Product Change Notice (PCN)

PCN Number: **PCN-0456243R-01**

Product(s) Affected: **SJ1-353XNS series. SJ1-3533NS, SJ1-3534NS & SJ1-3535NS**

PREVIOUS CUI DETAIL/IMAGE	NEW CUI DETAIL/IMAGE

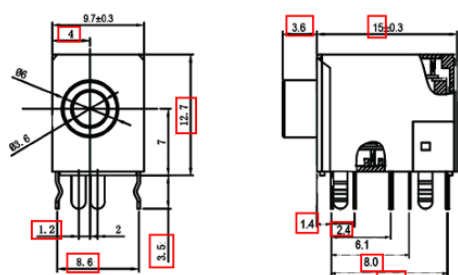
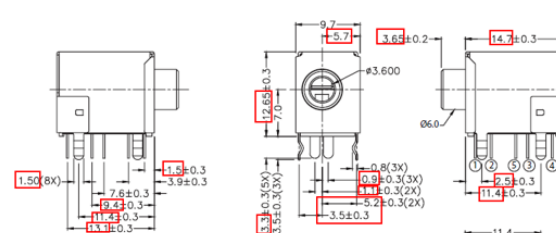
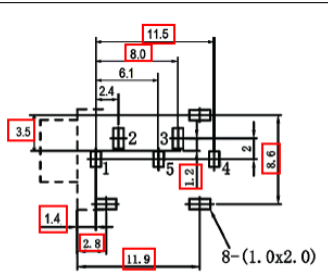
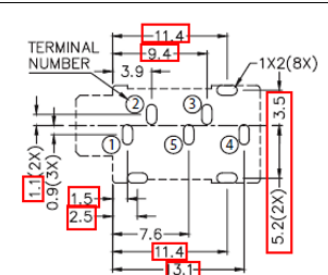
Description of Change: **New Factory Location. Product re-engineered for improved manufacturability and production yield. See image below for reference and check CUI Devices website for updated drawing. Cosmetic differences may be visible but will not affect the form fit and function of the product.**

PREVIOUS CUI DETAIL/IMAGE			NEW CUI DETAIL/IMAGE		
DESCRIPTION	MATERIAL	PLATING/COLOR	DESCRIPTION	MATERIAL	PLATING/COLOR
terminal 1	brass	silver	terminal 1	brass	tin
terminal 2	phosphor bronze	silver	terminal 2	brass	tin
terminal 3	phosphor bronze	silver	terminal 3	brass	tin
terminal 4	brass	silver	terminal 4	brass	tin
terminal 5	brass	silver	terminal 5	brass	tin
spring	stainless steel	nickel	spring	stainless steel	
bushing	brass H59	nickel	bushing	brass	nickel
shield	SPCC t=0.30	nickel	shield	cold rolled steel	nickel
housing	PBT (UL94V-0)	black	housing	PBT (UL94V-0)	black
